### AMENDMENT 2

#### Request for Proposal (RFP) UOG RFP No. P24-04

#### <u>"INDEFINITE DELIVERY/INDEFINITE QUANTITY INSTALLATION OF CAMPUS-WIDE ACCORDION-TYPE</u> <u>TYPHOON SHUTTERS"</u>

#### **QUESTION & ANSWER SHEET NO.1**

Reference picture # 1 (RFI # 6)

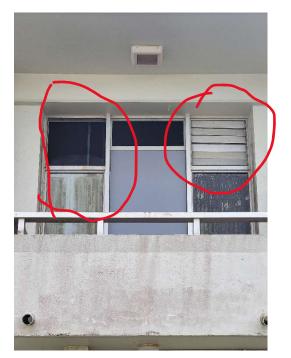
- Question 6: For Guma'Ta Hall For a few windows at the back side of the building, the window glass is only in the center. The top and bottom of the glass are aluminum louvers. Please confirm if the shutter needs to cover only the glass portion or including the louvers. If the shutter tracks are mounted only on the sides, the shutters will not meet the wind load. See reference picture #1 attached.

For Guma'Ta Hall – For a few windows at the back side of the building, the window glass is only in the center. The top and bottom of the glass are aluminum louvers. Please confirm if the shutter needs to cover only the glass portion or including the louvers. If the shutter tracks are mounted only on the sides, the shutters will not meet the wind load.

- *Answer:* The shutters will cover the entire window frame.
- Question 7: Please confirm if the window above the Gas Tanks on each building must be included in the bid. Reference picture # 2 attached.
